**TOWN OF MELBOURNE BEACH**

**PLANNING & ZONING BOARD  
MEETING**

**Section:** New Business  
**Meeting Date:** June 2, 2026  
**From:** Building Department  
**RE:** Site Plan Approval for 2103 Redwood Ave. – Addition

## Site Plan Review

**UPPER FLOOR PLAN**

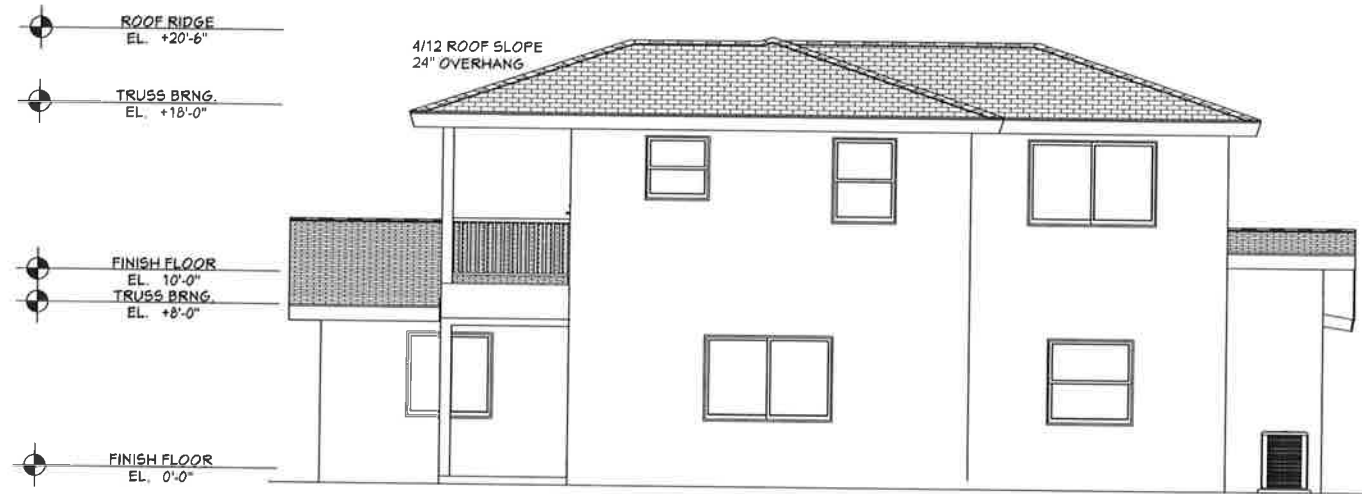
- 1) The project is continued from the May meeting of the Planning and Zoning Board to address an issue with the cantilevered 2<sup>nd</sup> floor space, and the revised plans have corrected the 2<sup>nd</sup> floor to comply with the side yard setback requirements. The project involves the construction of a 3-bedroom / 2-bath 2-story addition to an existing single-family home. The existing 1-story home includes a gross area under roof of 1,820 square feet based on the Property Appraiser's information. The proposed 2-story addition will include three (3) bedrooms, two (2) baths, great room, game room and covered porch for the first and second floors, and a gross area under roof of 1,631 square feet. The game room on the 2<sup>nd</sup> floor of the addition includes a refrigerator, double-sink and dishwasher which appears like a kitchen, although a kitchen is defined as having cooking facilities and there is no oven/range to qualify as a kitchen, so this would not be considered an additional dwelling unit.

Based on the above, the minimum “yard” area for the side yard between the principal building and the side lot line is 15'. The proposed second floor cantilevered space in the design of the proposed addition at 222 Sixth Avenue is less than 15' and cannot be permitted, and as such the plans must be redesigned to comply with the 15' yard requirement. Please let me know if you have any questions.
